SUPPLEMENTAL INSTRUCTION

PROJ.: Meridian Community
Building Rebuild
PROJ. No.: 1841
DATE: Oct. 8, 2019
S.I. No. S.I. – A012

12.1 TITLE

CONTRACTOR'S INFORMATION REQUEST FORM

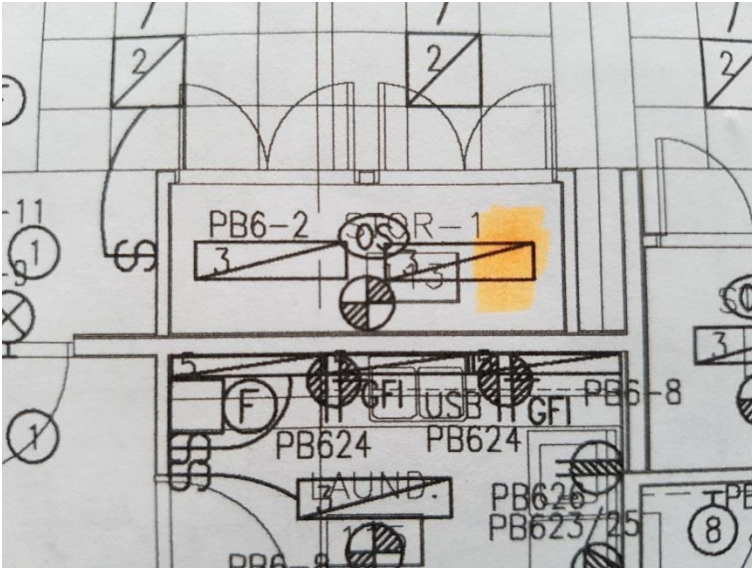
1. Please confirm new location for Light Fixture Type 3 in Storage Room #113 due to Attic Access Hatch interference. Access Hatch size is 550mm x 900mm. Location of access hatch is highlighted in orange on the attached photo. Edge of Attic Access Hatch is approximately 40" from wall.

.1 Delete one light fixture in Storage Room 113 as per the response to CIR #29 by Goodkey, Weedmark & Associates. Centre remaining light in the room. Turn deleted light fixture over to owner.

One Type 3 light fixture to be deleted to accommodate roof access hatch.
